From: Lasley, Timothy G
Sent: Thursday, July 18, 2019 12:06 PM
To: lcoile@glaveandholmes.com
Cc: Werner, Jeffrey B
Subject: BAR Action - July 16, 2019 - 1824 University Circle

BAR 18-04-04
1824 University Circle
Tax Parcel 060097000
Jake Rubin, Owner/Applicant
Modifications to Pergola

**CITY OF CHARLOTTESVILLE
BOARD OF ARCHITECTURAL REVIEW
STAFF REPORT
July 16, 2019**

BAR 18-04-04

B1 PERGOLA ELEVATION - OCTAGONAL TO SQUARE POST W/ STUCCO BASE & PRECAST CAP
SCALE: 1/2" = 1'-0"

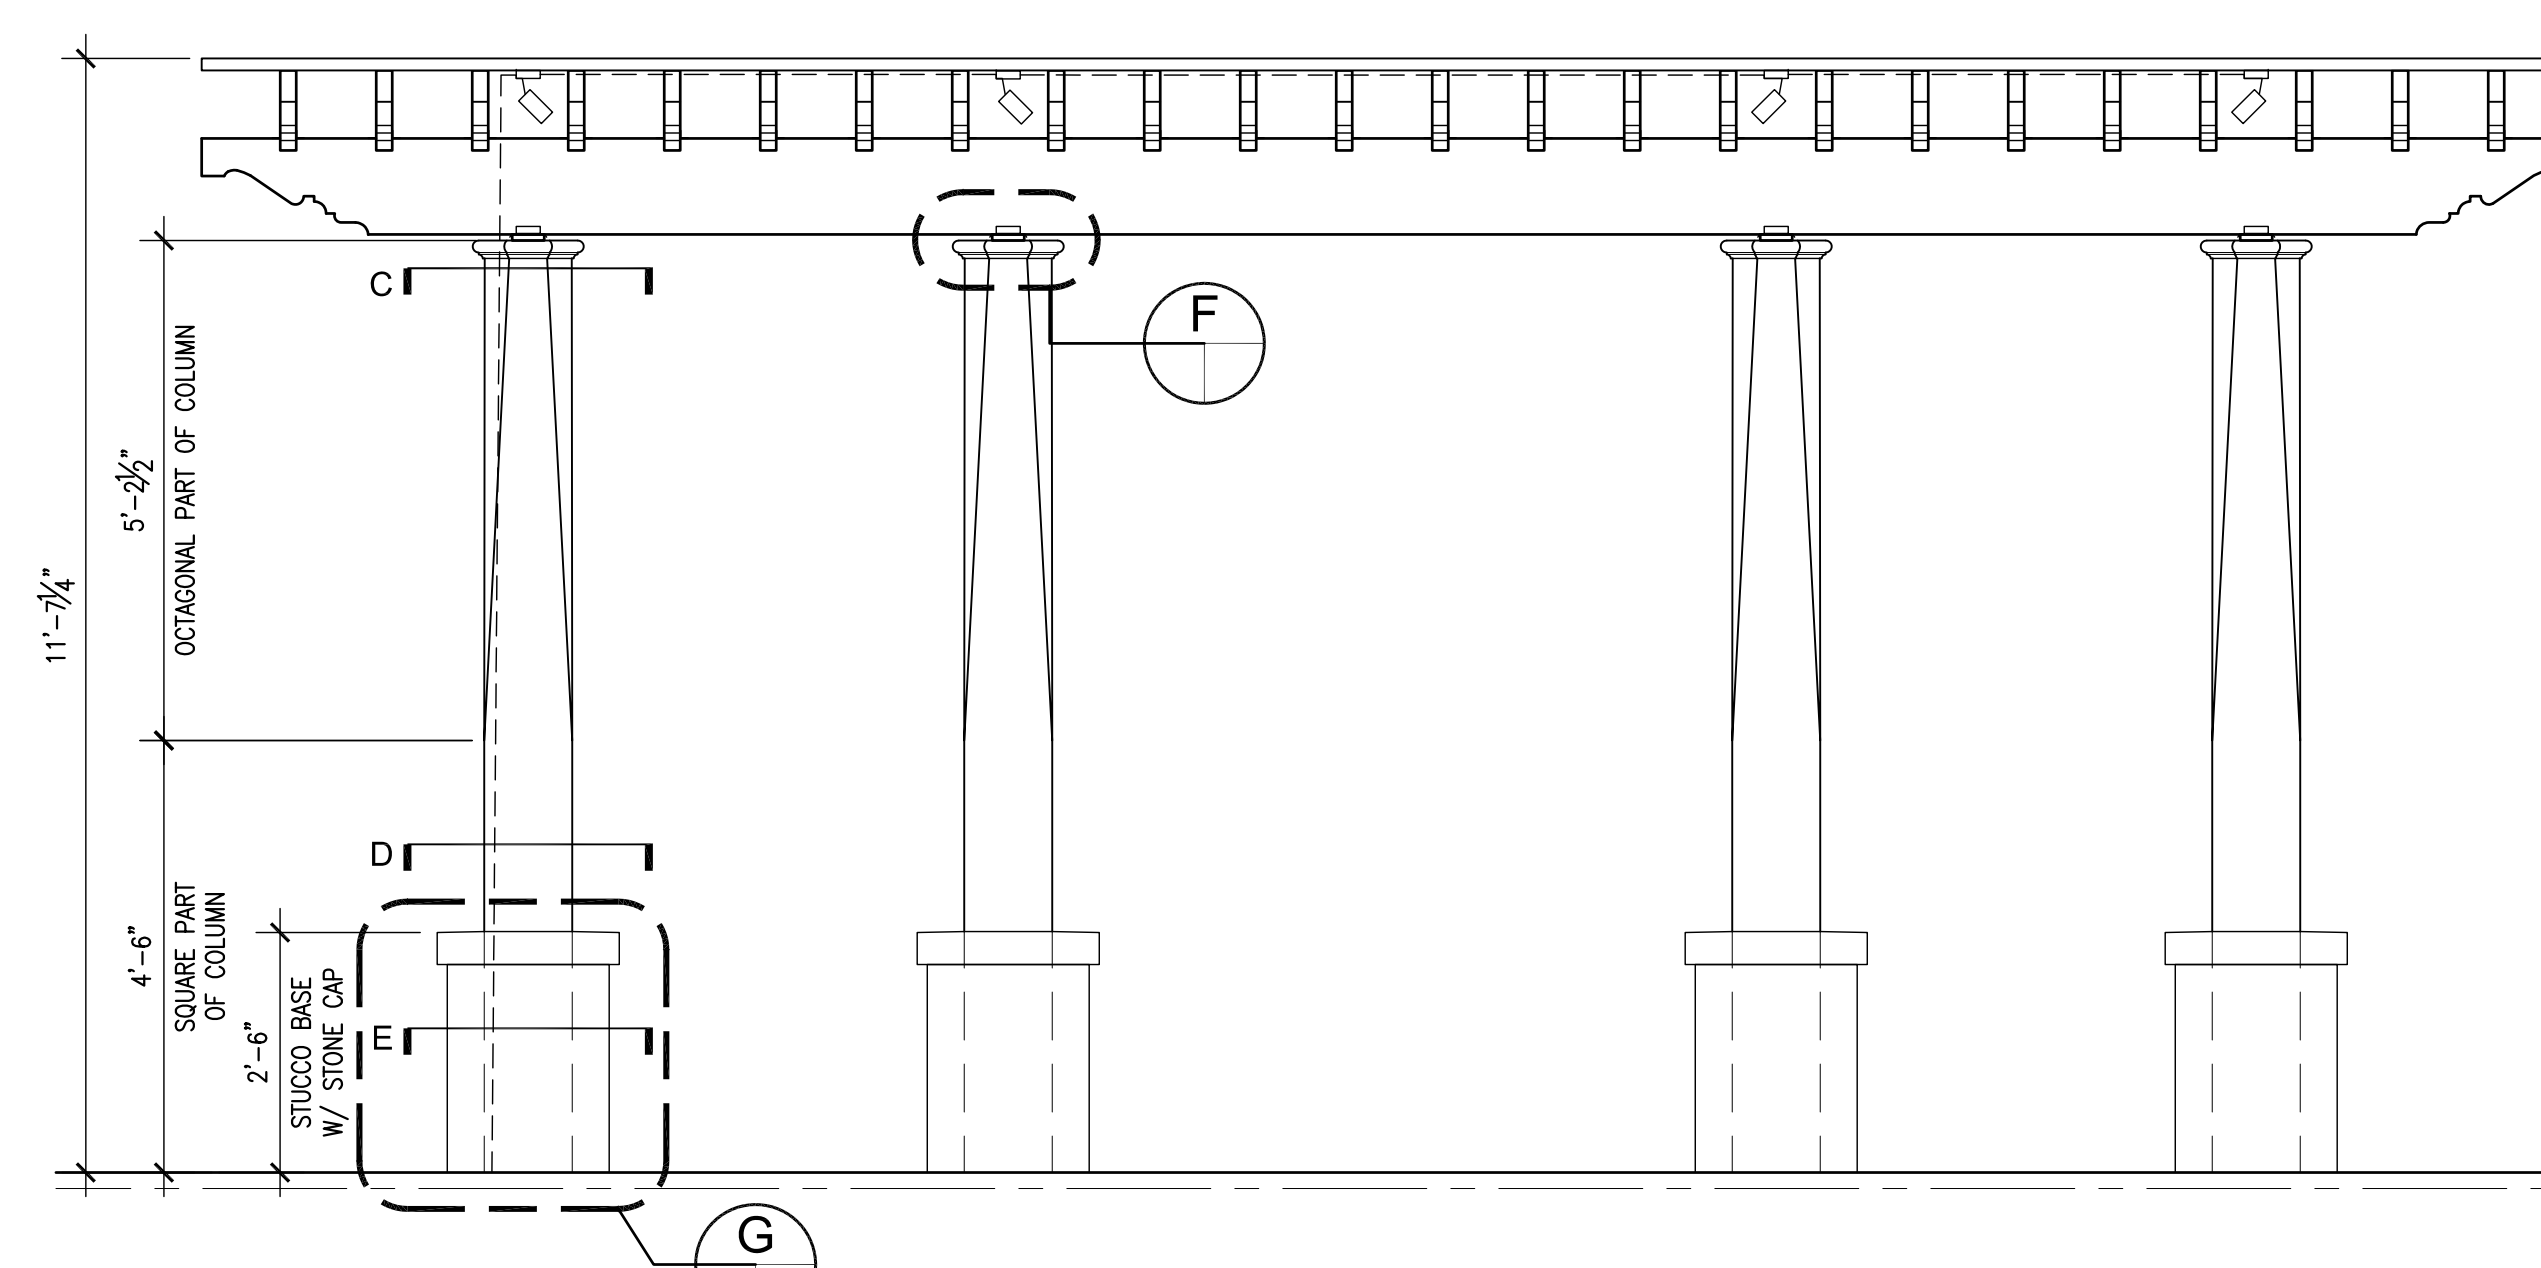
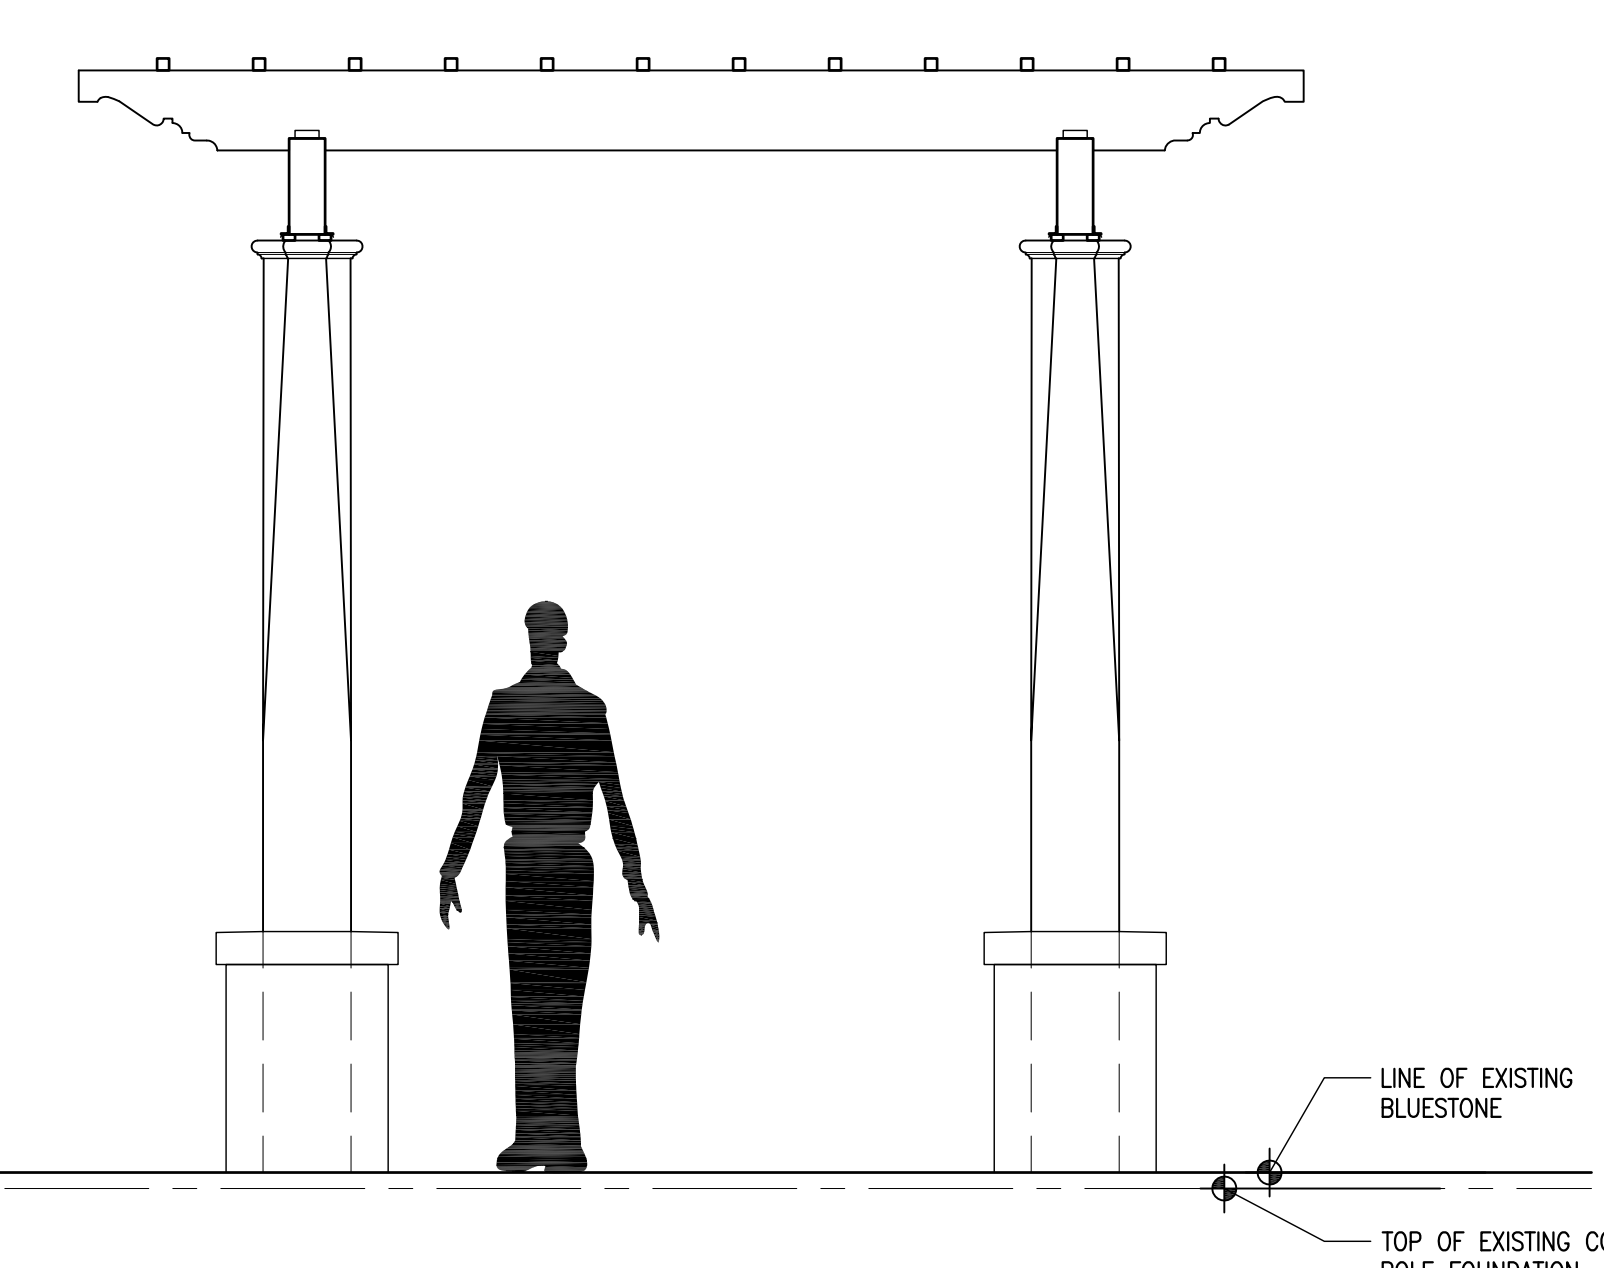
Replace the previously approved Doric columns on the rear pergola with simple, 11" x 11" square posts that taper into an octagon profile. No changes are proposed to the approved purlins and rafters.

Note: At the BAR's June 18 meeting, the applicant introduced some of the options being considered. The BAR was generally receptive, with a suggestion that the simpler posts be at least 10" square.

The proposed change is consistent with what was presented to the BAR in June. The intent of the change is to create a representation of a light tent-like structure during the Sukkot holiday, a time to celebrate the Israeli Exodus from Egypt.

The pergola is a new element at the site. The original design reflected the existing Doric columns on the building, however the proposed changes are not incompatible with the design and scale of the existing structure.

Approved on the consent agenda. Having considered the standards set forth within the City Code, including City Design Guidelines for Site Design and Elements, I move to find that the modifications to the pergola satisfy the BAR's criteria and are compatible with this property and other properties in the Rugby Road-University Circle-Venable ADC District, and that the BAR approves the application as submitted.

Staff recommends approval.
